**Preliminary Field Check For Drip Systems**

RE: ***642 Lakebreeze Dr.  
Canyon Lake Hills 6  
Lot 2347R***

Thank you for your submission. We have reviewed the planning materials for the referenced permit application, and unfortunately, they are insufficient. To proceed with processing this permit, we require the following:

| PREPARED BY: GREG W. JOHNSON, P.E. F#002585 | SCALE: 1"=40'         | DATE: 2/24/2025   | REVISED:   |

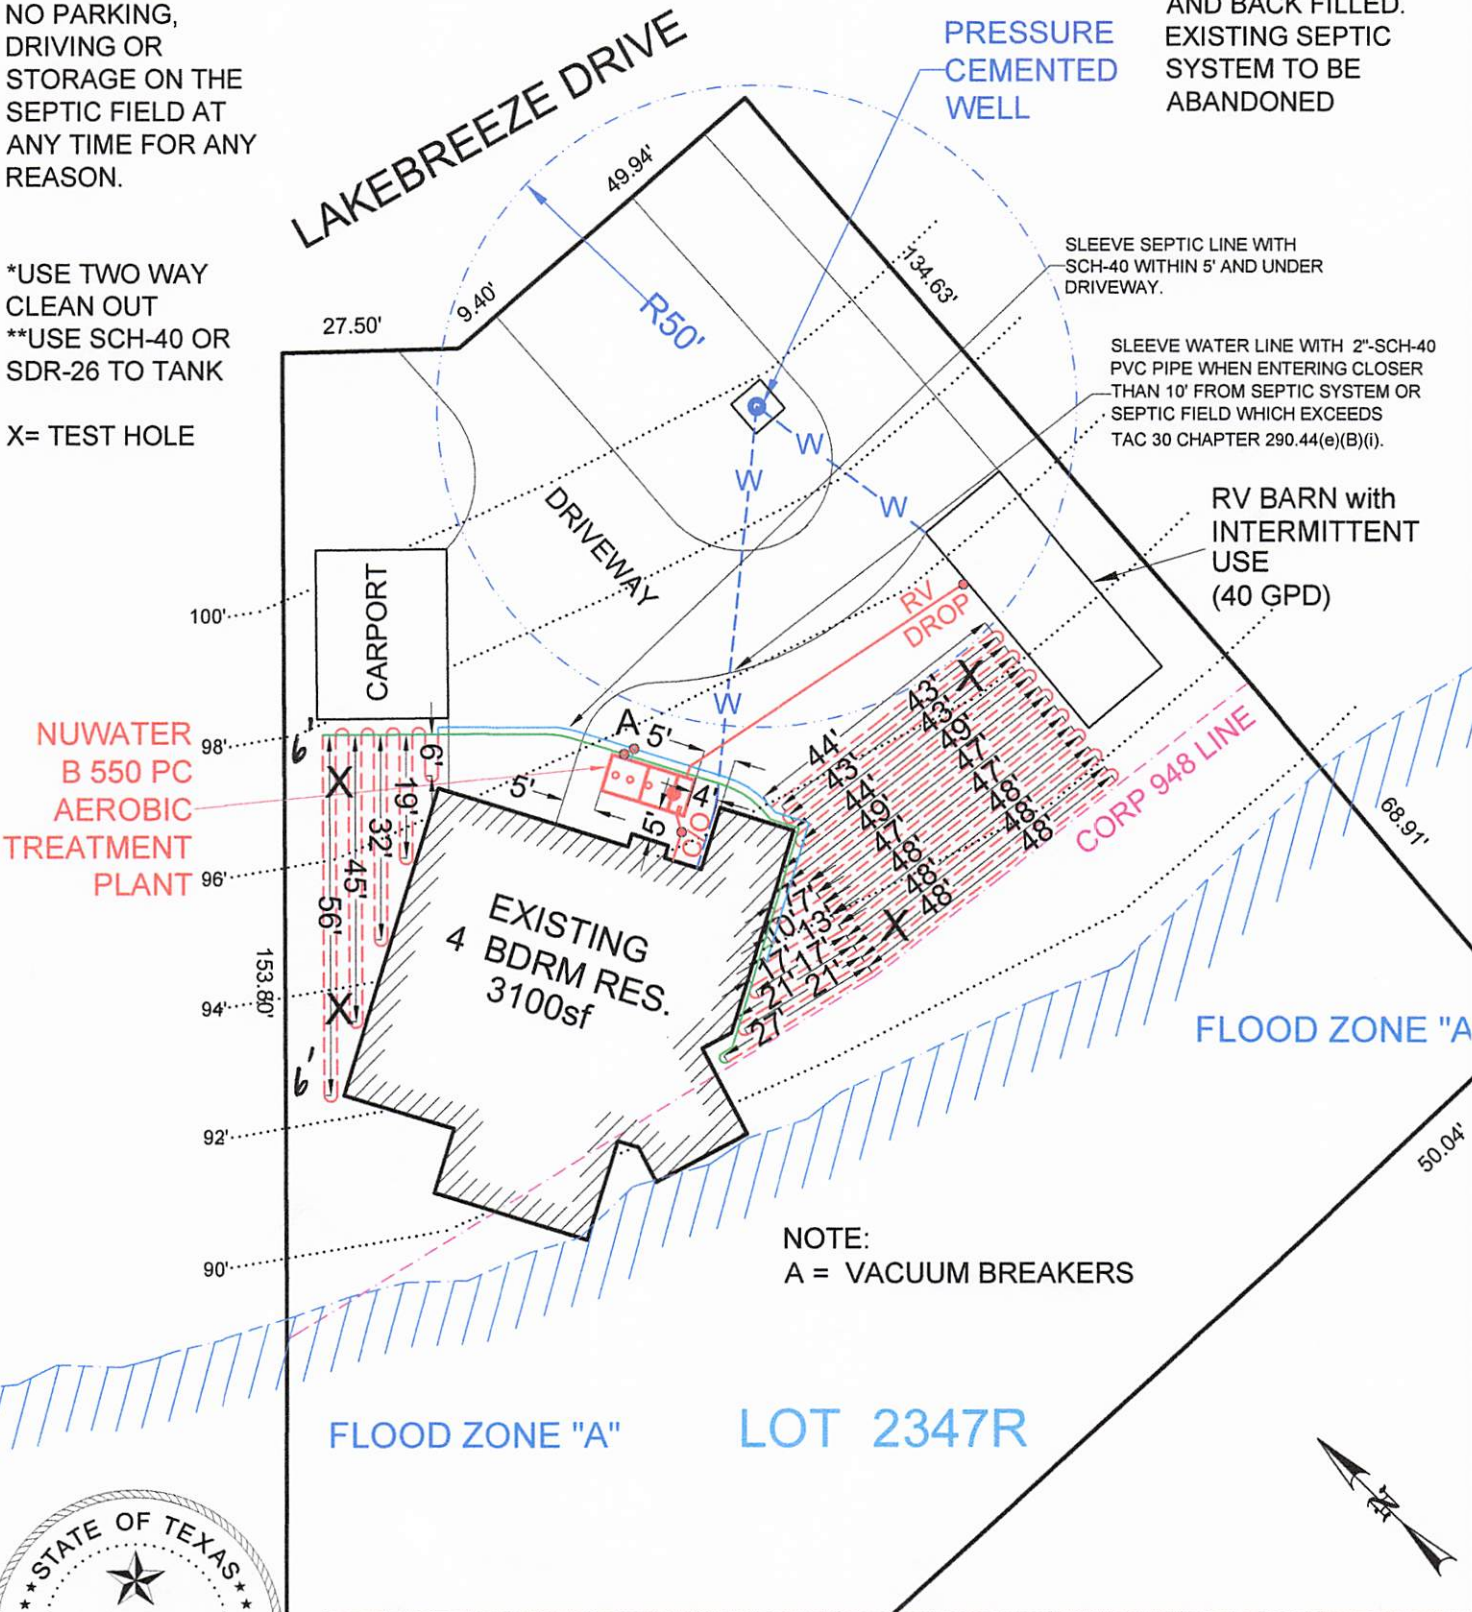
1. 285.91(10) There is a 5 ft separation distance from tanks and foundations.
2. Revise accordingly and resubmit.
